**CITY OF WARWICK, RHODE ISLAND
WARWICK SEWER AUTHORITY
BAYSIDE SEWER SYSTEM PRESSURE SEWER
CONTRACT 86B
ADDENDUM NO. 2**

January 8, 2020

The following information is provided as part of the Contract Documents as Addendum No. 2.

DETAILS - 3
PAVEMENT & WATER

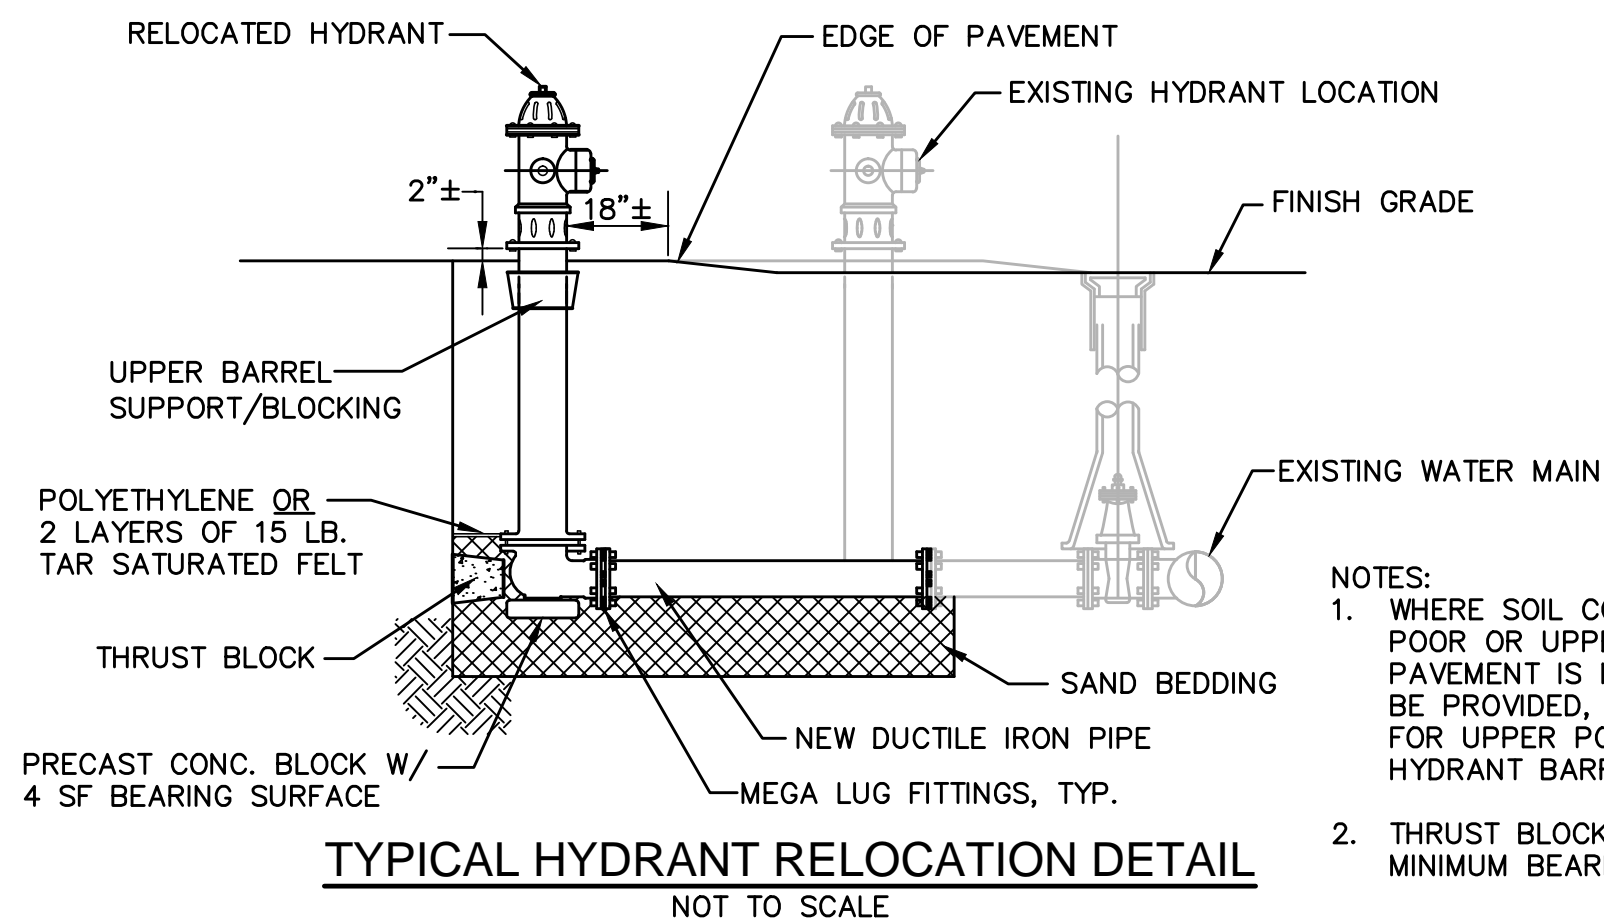
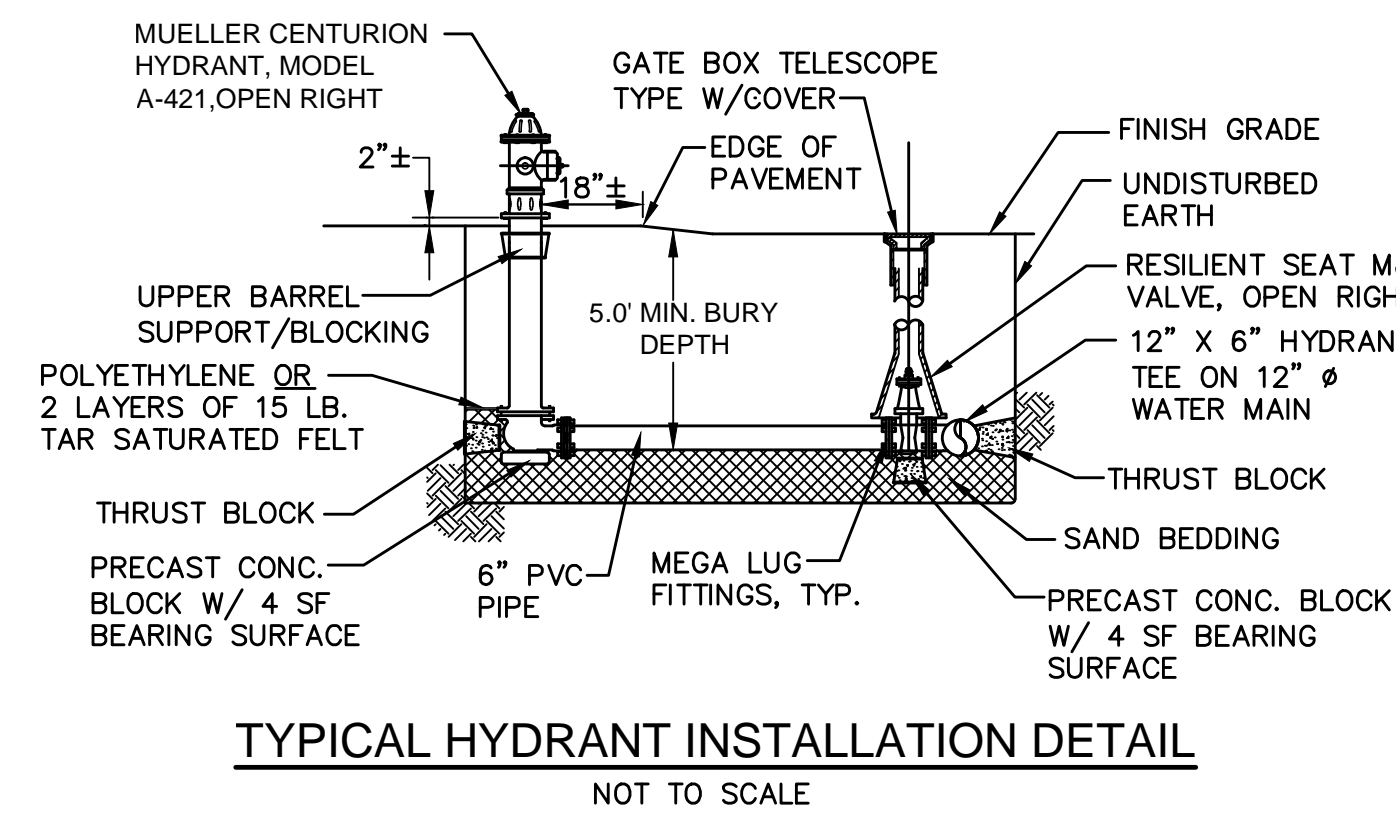
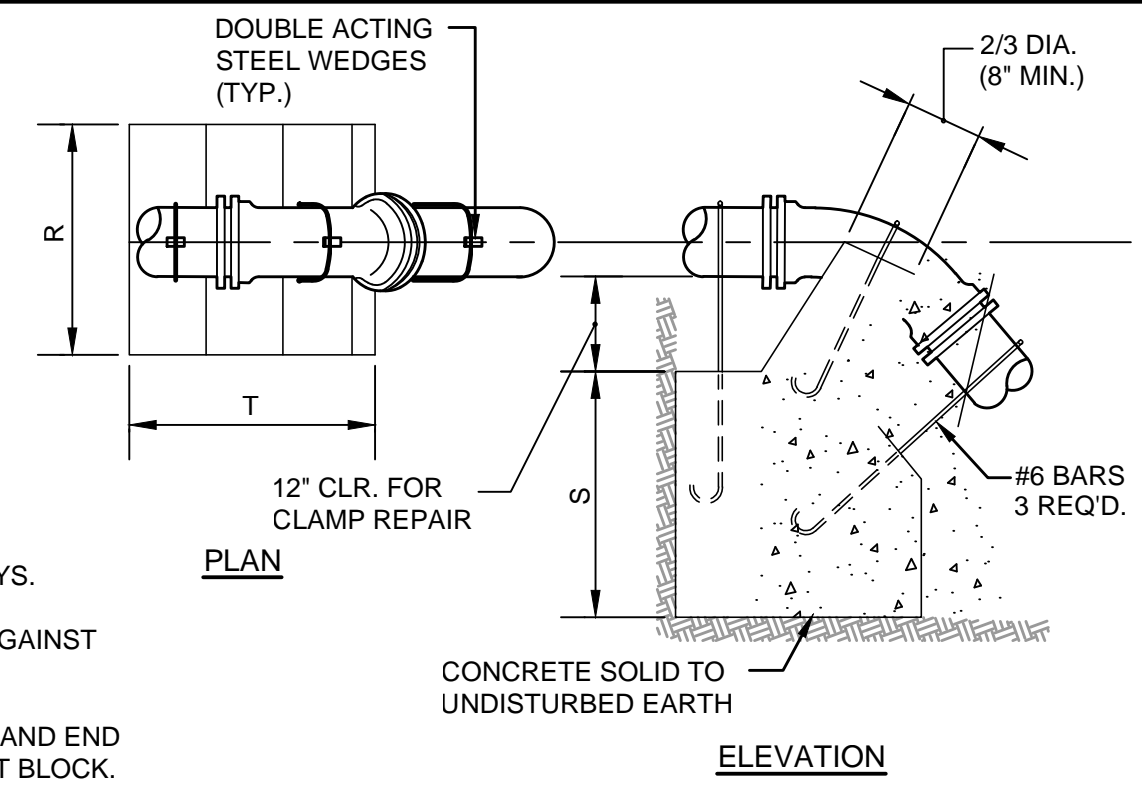
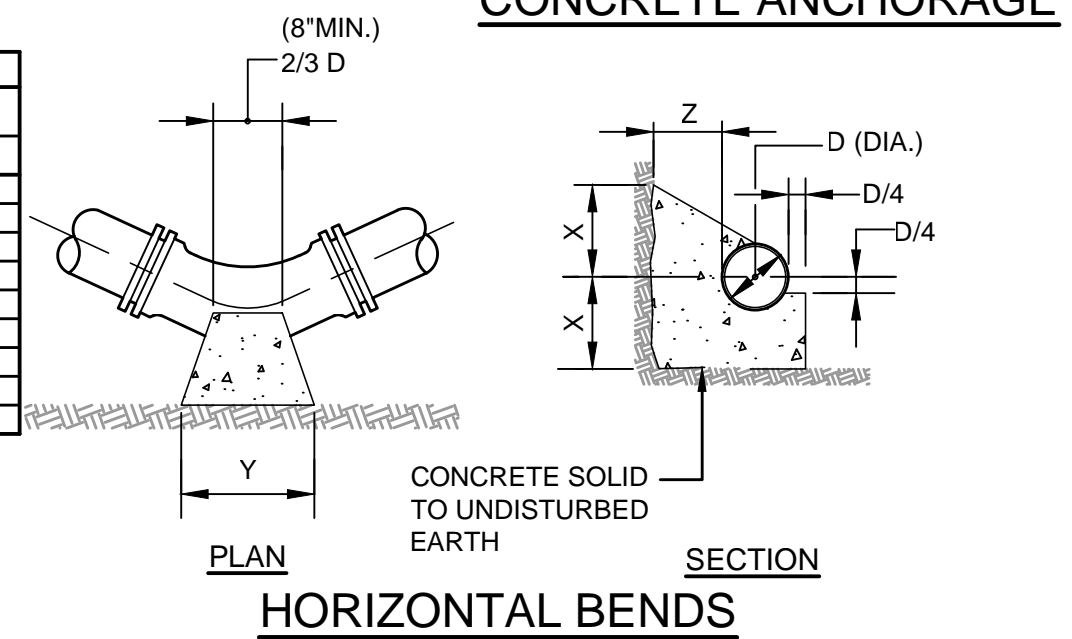
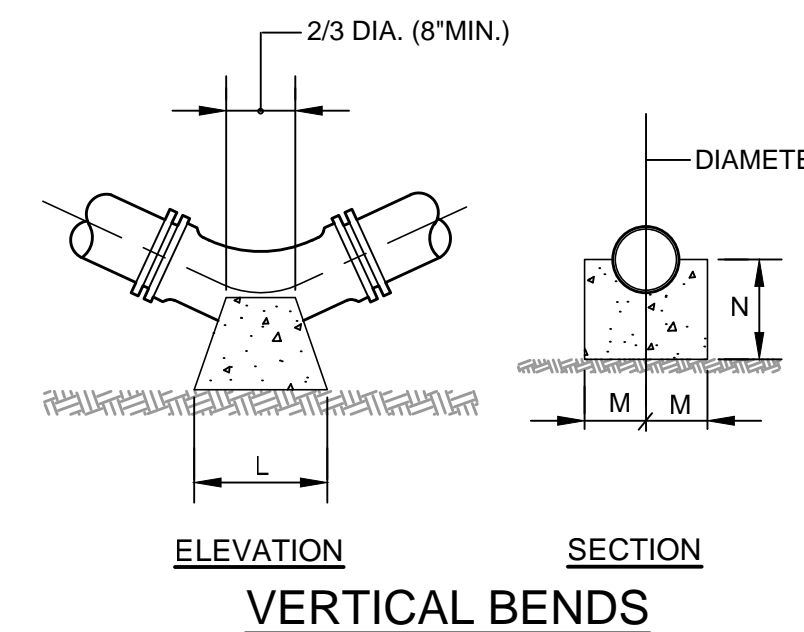
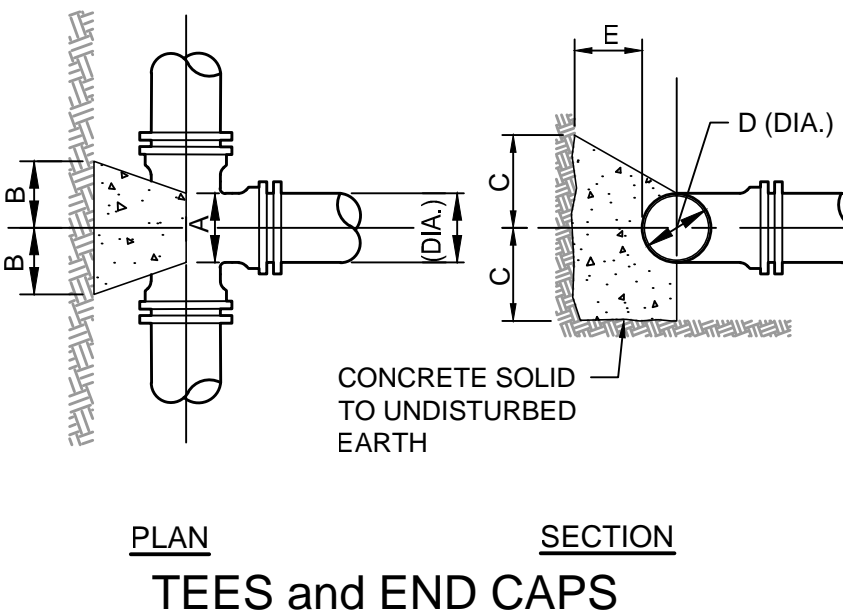
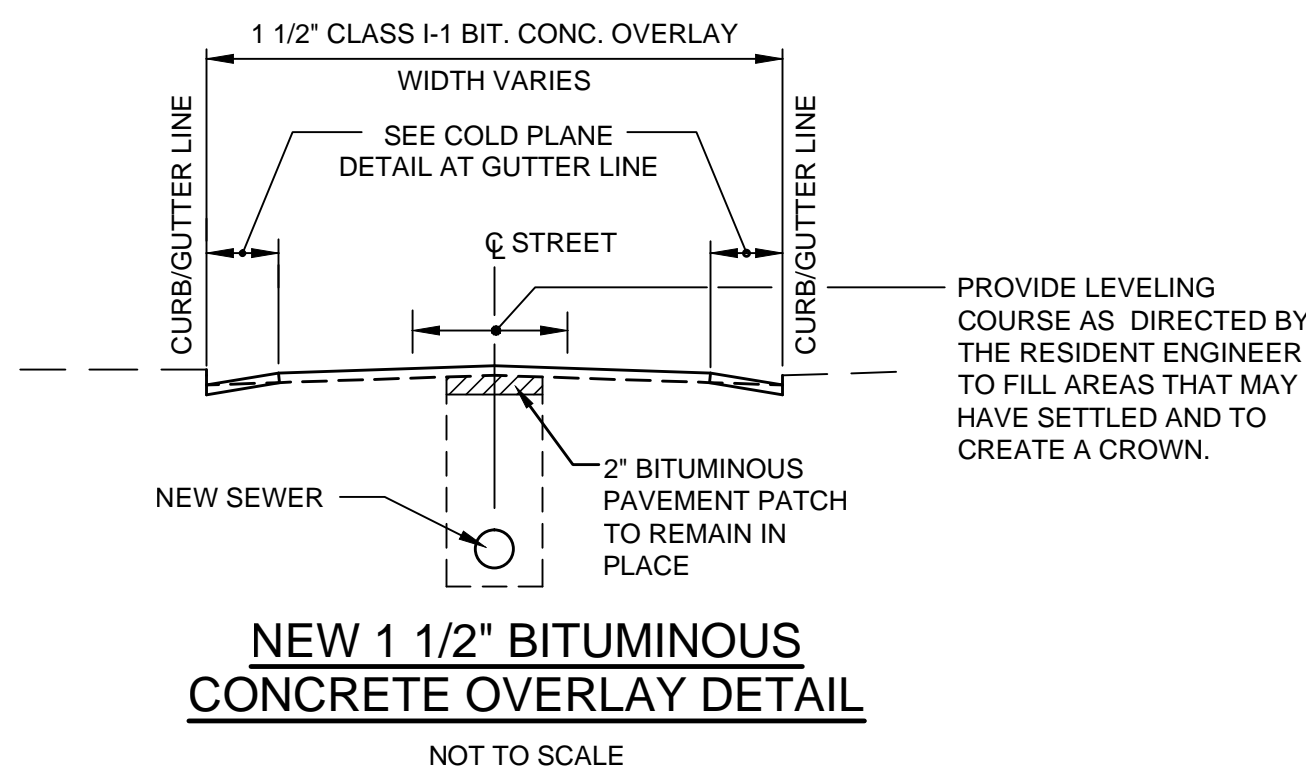
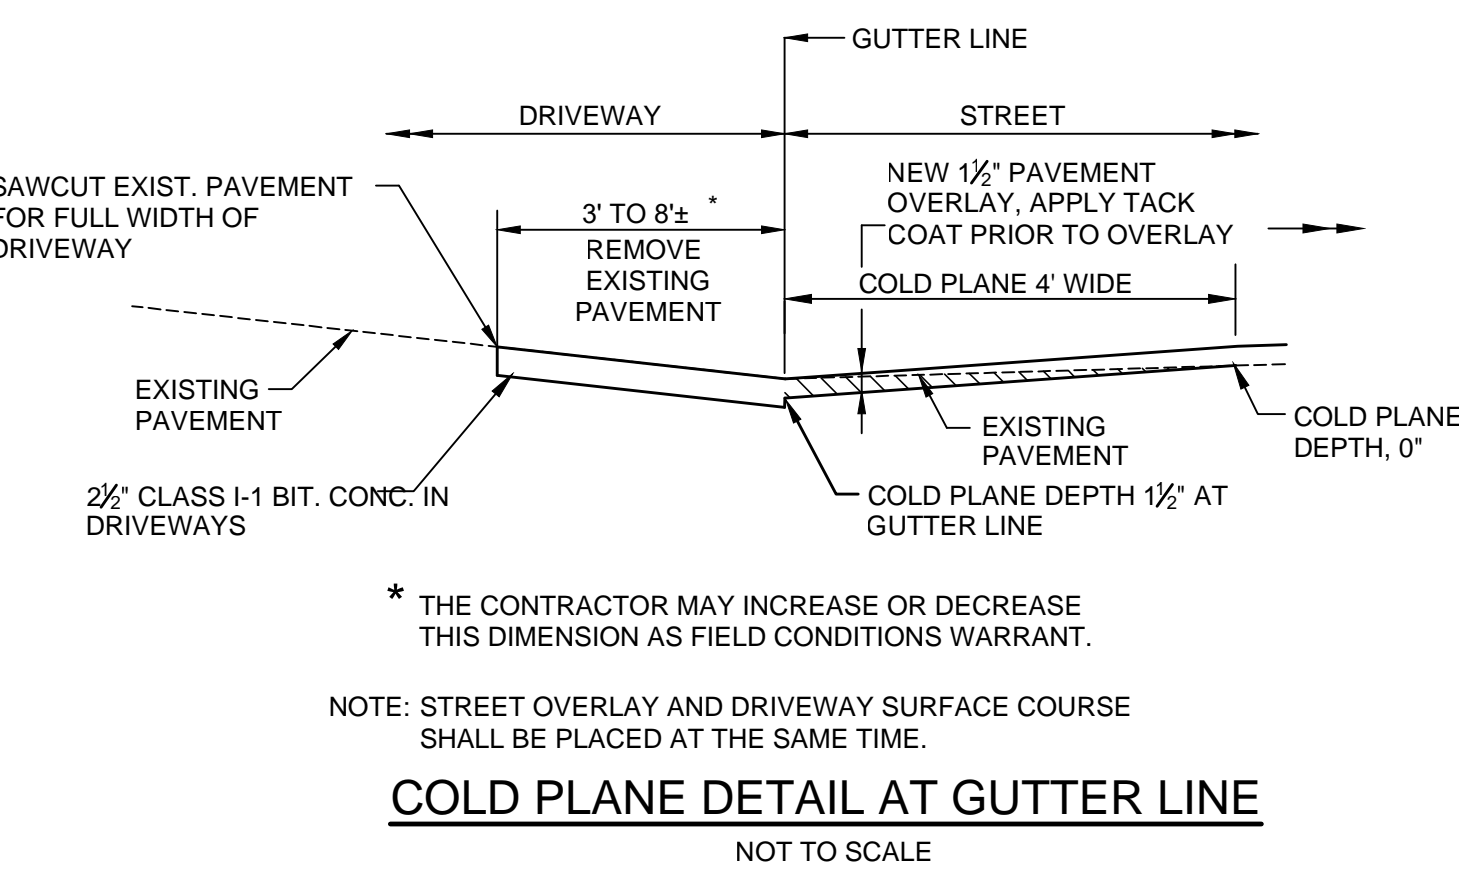
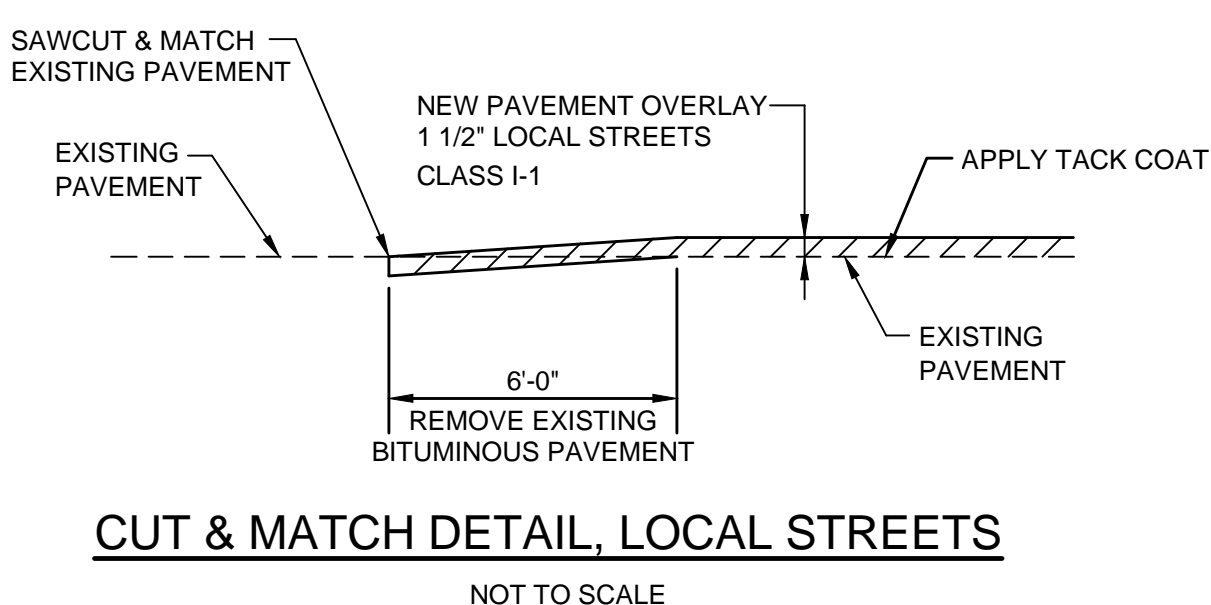
1. Plan Sheet No. 58 Details – 1, Open Excavation, Delete and Replace with the attached Plan.
2. Plan Sheet No. 60 Details – 3, Pavement and Water, Delete and Replace with the attached Plan
3. Plan Sheet No. 62 Details – 5, Open Trench Excavation, Delete and Replace with the attached Plan.
